Opal St Clair

Response to letter 19th November 2021

17th June 2022

New acoustic fence to boundary

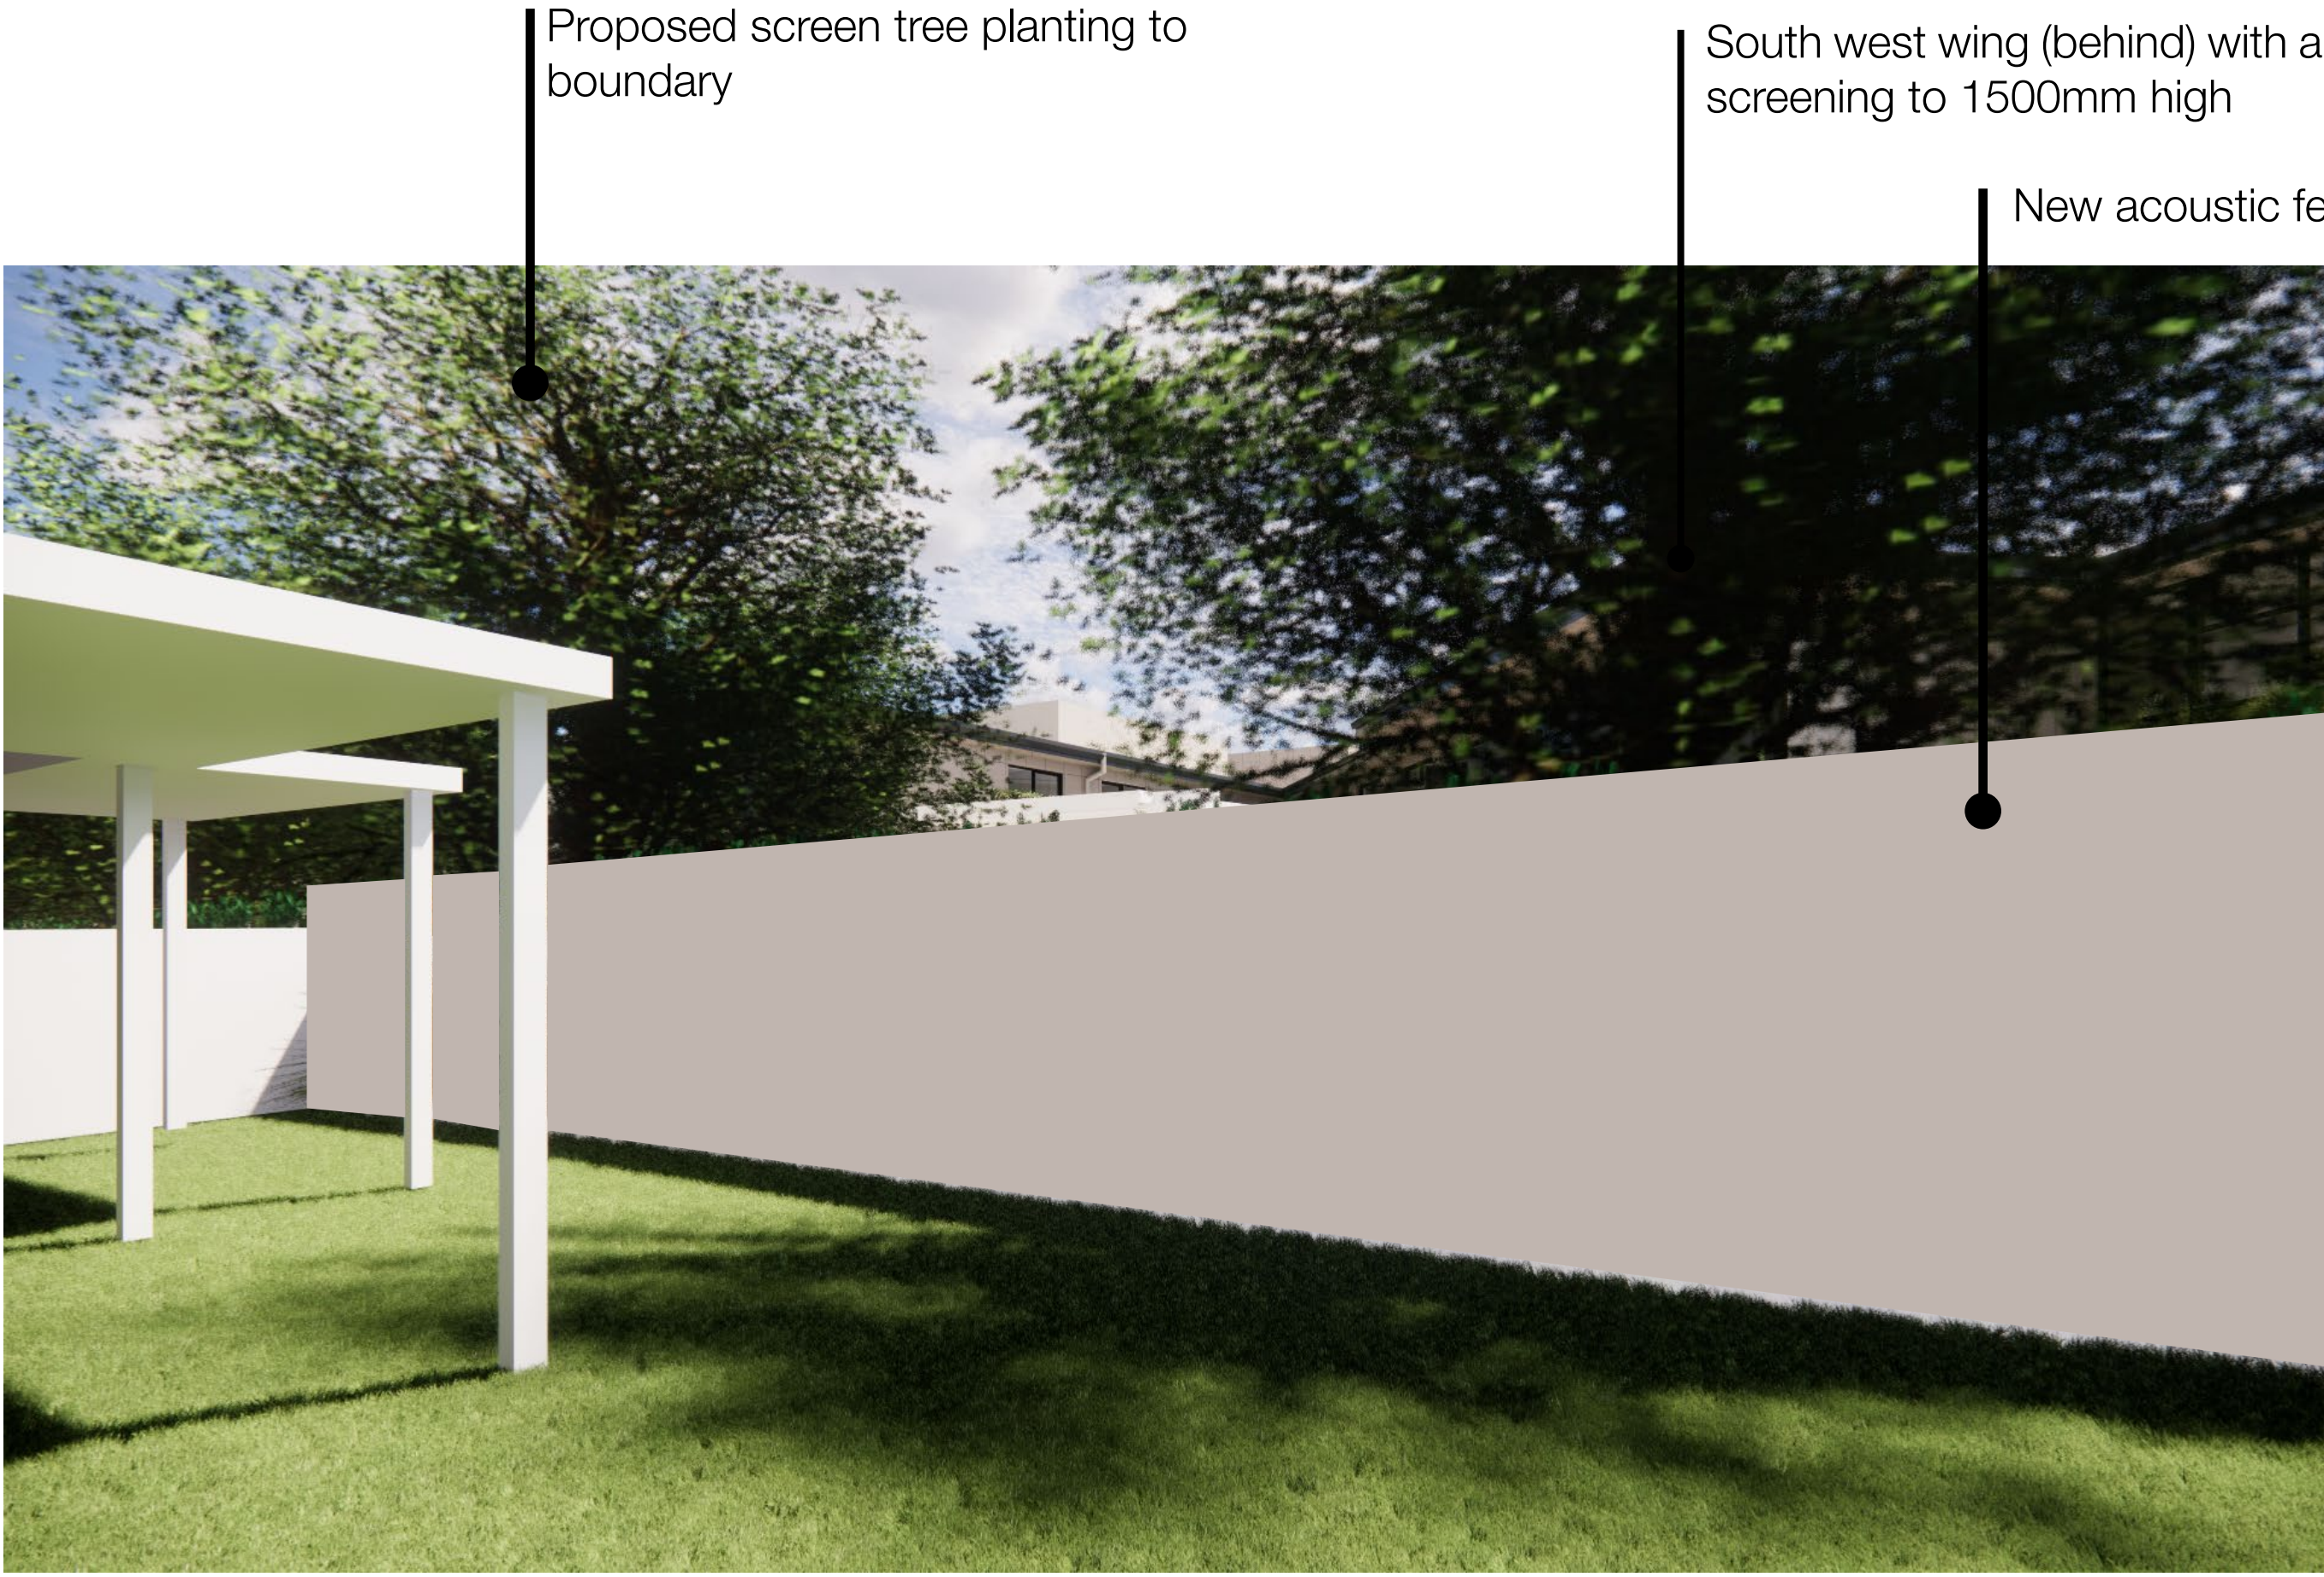
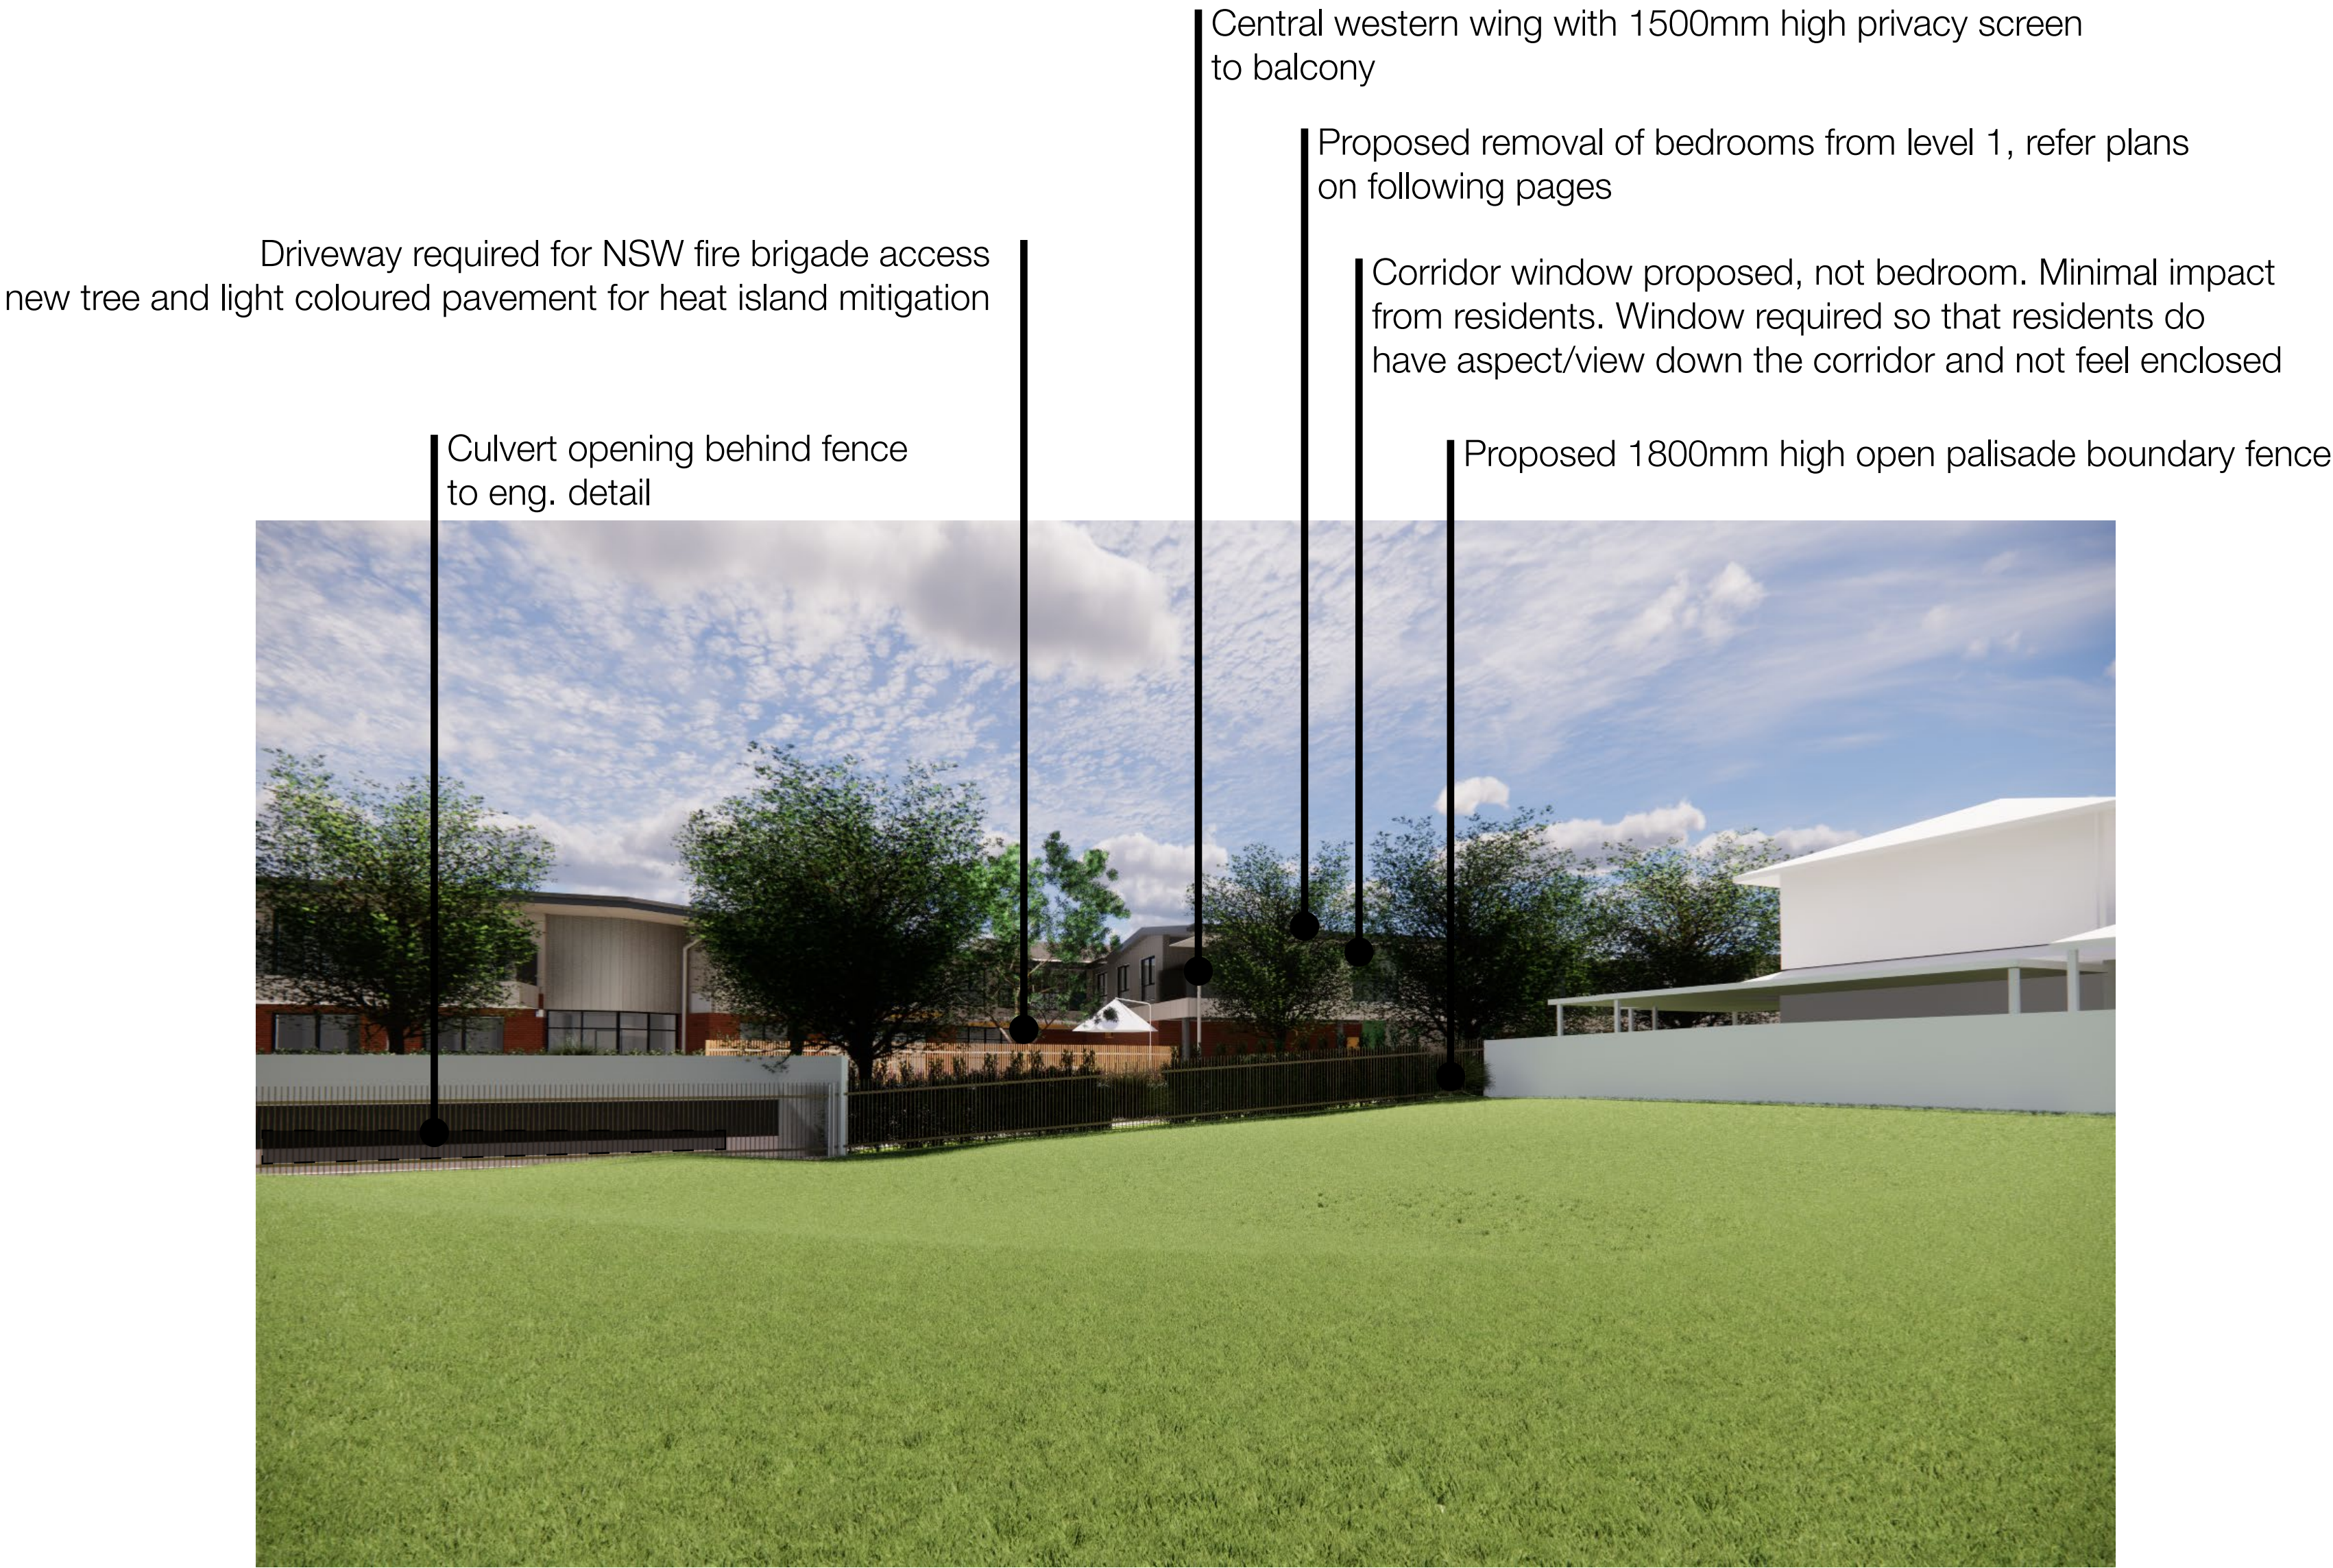
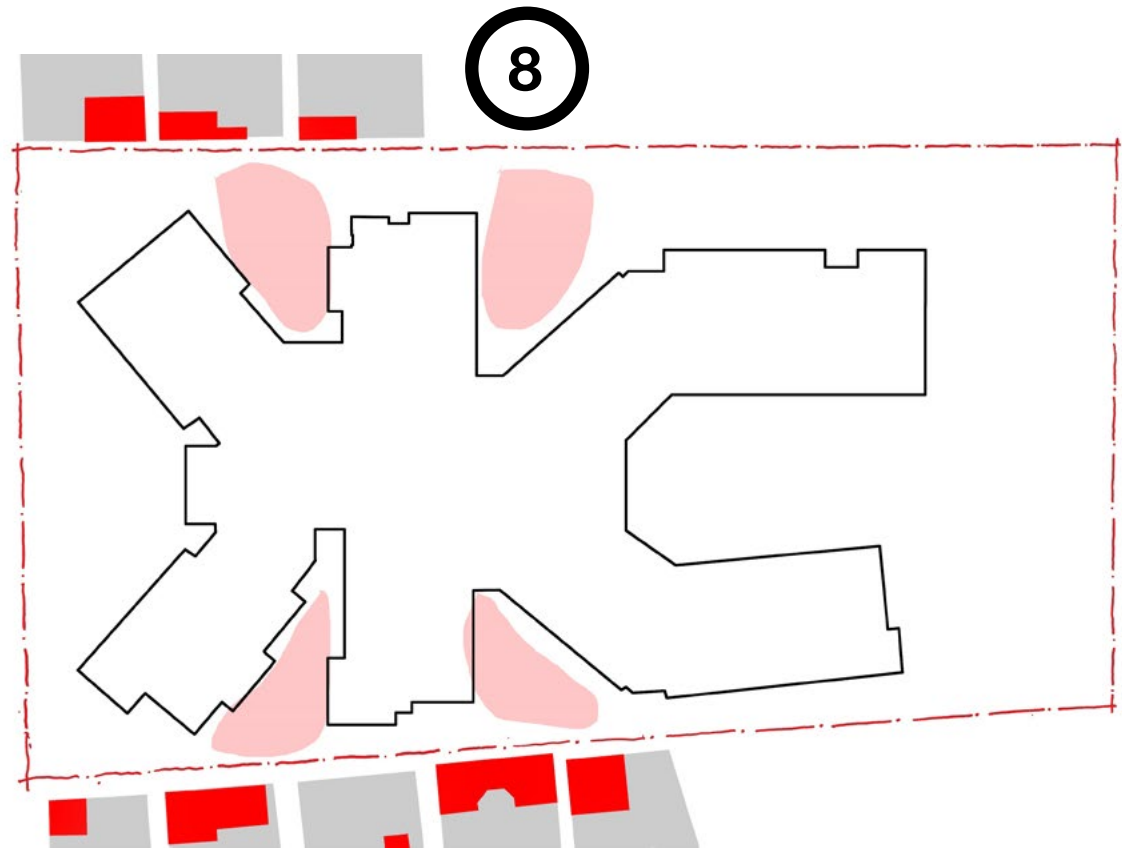
Concern is raised regarding the overall bulk of the building, including the extension of the front and central building wings to within close proximity of the side boundaries, the extension of the north eastern wing to within close proximity of the eastern side boundary, and the provision of ground floor levels which are significantly above the existing ground levels (i.e. up to approximately 2.5m above in the north eastern corner of the development). It is noted that Council's Urban Design Review Panel have reviewed the proposal and have raised issue in relation to the insufficient vertical expression, apparent building length and overall building bulk

The proposed facade treatment adjoining neighbouring dwellings is highly articulated with residential scale particularly in relation to the southern and central wings. A number of views from neighbouring properties have been prepared to illustrate this when viewed from the POS of adjoining properties (shown in red).

Further to the above, modifications are proposed to the building mass through the removal of first floor bedrooms amongst other internal changes. These improvements are reflected in the updated views and the proposed plans reflected on pages on 10 and 11
